Addendum for Updated EPP / Master Key Loading

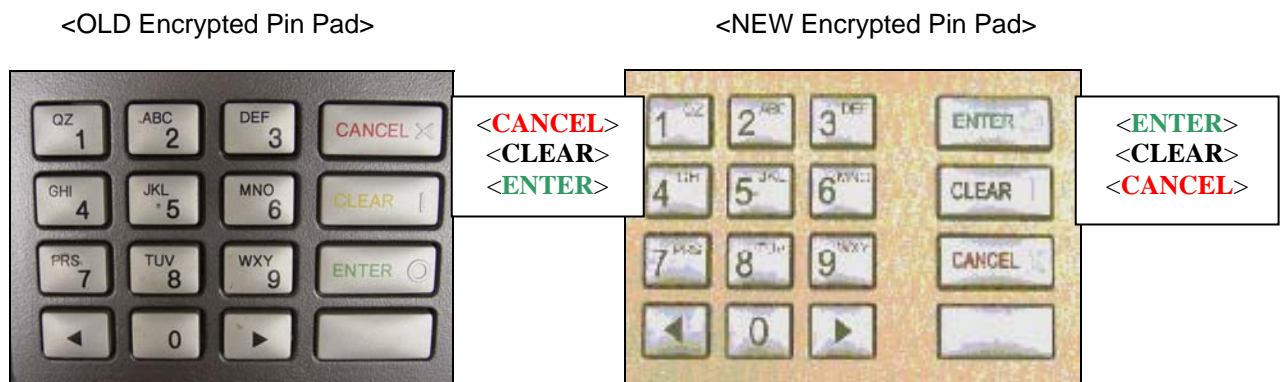
There are two different Tranax pin pad styles. The principle difference between the two is the placement of the ENTER and CANCEL keys. They are switched. The new style pin pad has the ENTER key on the upper right hand corner of the keypad. The old style had the CANCEL key in the upper right hand corner.

One of the effects of this new configuration is a change in how master keys are entered. The old format (see below on left) had the D in the top right position and the F in the third from top position. The new format (see below on right) has the F key in the top right and D in the third from the top position.

New keypad serial number will begin **OAFIxxxxxx** (old style is OACIxxxxxx) These two parts are not interchangeable.
